PLANNING STAFF REPORT
Schoolview Major Subdivision (formerly Scott Gerow Subdivision)
Planning Board Hearing

Hearing Date: May 5, 2009
Applicant: Southwind Engineering
Property Owner: Scott Gerow
Case Number: PP 09-05-05-01R Southwind

Development Proposal: Revision of a Planning Board approved major subdivision. The proposal consists of 21 lots to be on 15.68 acres. This proposal is considered an amendment to the previously approved Preliminary Plat for Scott Gerow Subdivision now known, as Schoolview Subdivision.

FINAL PRELIMINARY PLAT

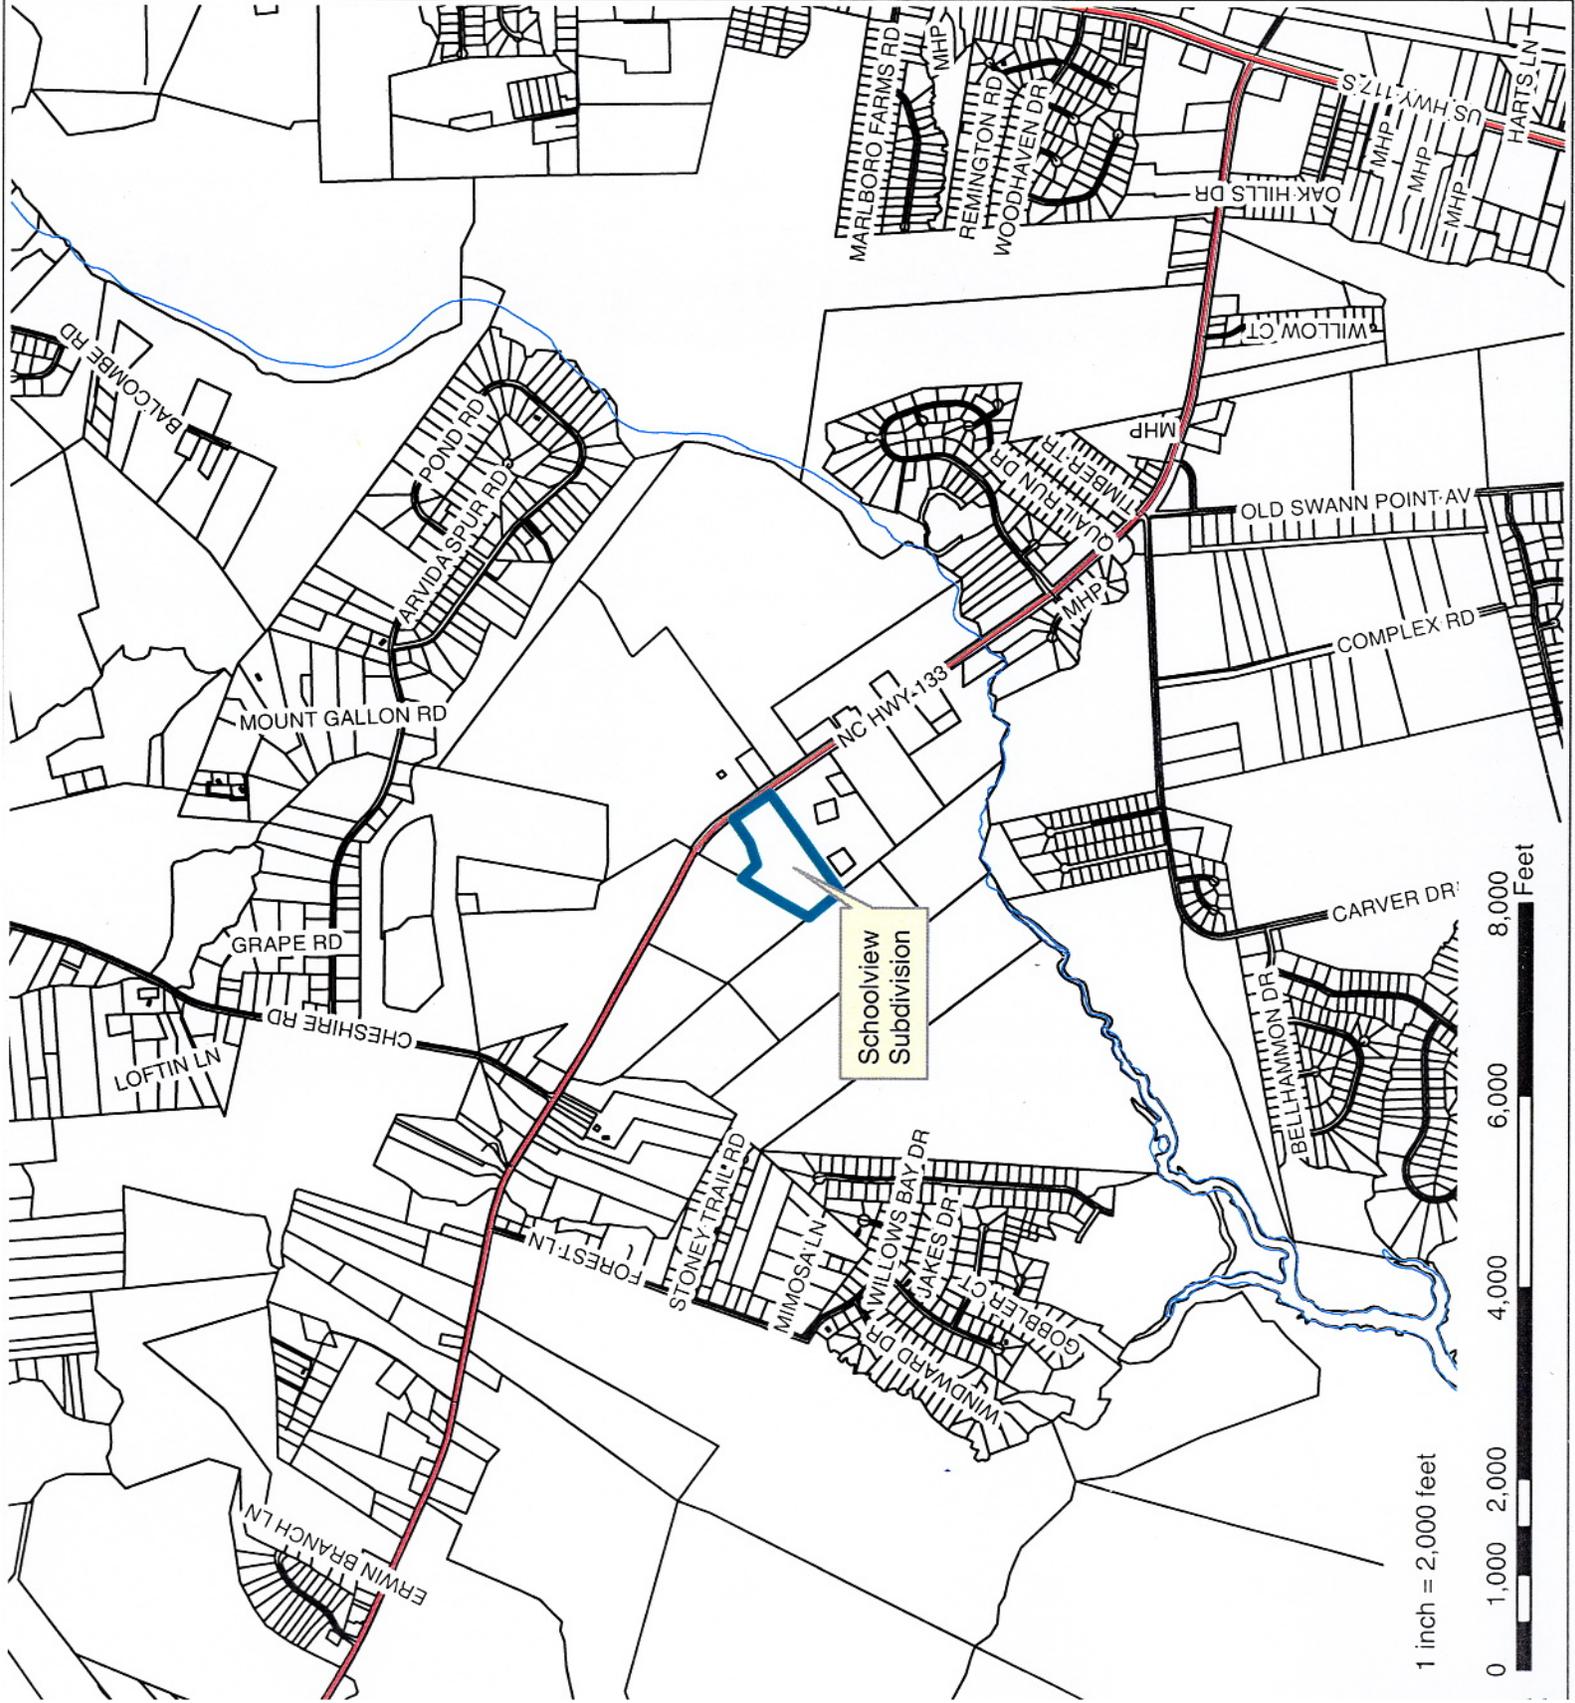
The applicant is requesting to amend the previously approved plan to include off-site septic systems instead of the individual septic systems as approved. Sixteen (16) of the off-site septic fields would be located along the western boundary of the subdivision accessible by a 30 foot access easement. The remaining off-site septic fields would be located on Lot 21 and Lot 1. Lot 21 would have three (3) septic fields and Lot 1 would have two (2) septic fields.

The minimum proposed residential lot size is 20,000 square feet meeting the district requirement of 20,000 square feet per lot in the R-20, Residential district. There is 3.53 acres of open space provided (approximately 22%), exceeding the County's 15% requirement. The applicant is proposing that 1.12 acres of the 3.53 acres of open space to be utilized in the off-site septic fields, leaving 2.41 acres of the open space. The open space will be accessible via a 30 foot access easement along Recess Lane.

All lots are proposed to be served by County water and individual off-site septic systems, subject to review and approval from Pender County Utilities and Environmental Health, respectively. All utility services will be underground.

The roads serving the subdivision will be dedicated public and the North Carolina Department of Transportation has approved the road plan. Recess Lane and Schoolview Drive will stub-out providing connectivity for future development.

3. Total and usable lot areas and required set back lines must be shown for each lot.
4. Public Water Systems
 1. Construction plans sealed by a registered engineer, as approved by DENR and Pender County Utilities Department;

6. Location of existing monuments and control points must be shown on the property.
7. The plat should clearly designate Wetlands, Areas of Environmental Concern, CAMA Setbacks, Flood Prone Areas (as shown on current FEMA maps), marshes, swamps, ponds, lakes, streams, and any other natural features on or affecting the site. If no Wetlands, AEC's or Flood Prone Areas exist on the site a note to that effect shall appear on the plat.

8. The plat must clearly designate Hydric Soils (Bohicket Silty Clay Loam, Carteret Fine Sand, Chewacla Loam, Croatan Muck, Dorovan Muck and Muckalee Loam) as shown on the NRCS county soil survey maps or from a Soil Suitability Analysis (required and received) prepared by a licensed Soil Scientist. If no hydric soils exist on the site a note to that effect shall appear on the plat.

9. Storm water management features must show all proposed storm water retention facilities including drainage easements, piping, culverts, swales, ditches, etc.

10. The plat must indicate the location and dimensions of existing and proposed right-of-ways & easements for utility, drainage or other facilities or structures. Easements with a width of 20' from center or 10' from the edge of all drainage facilities included on required drainage plans shall be shown for any such facilities not in public street right-of-way.
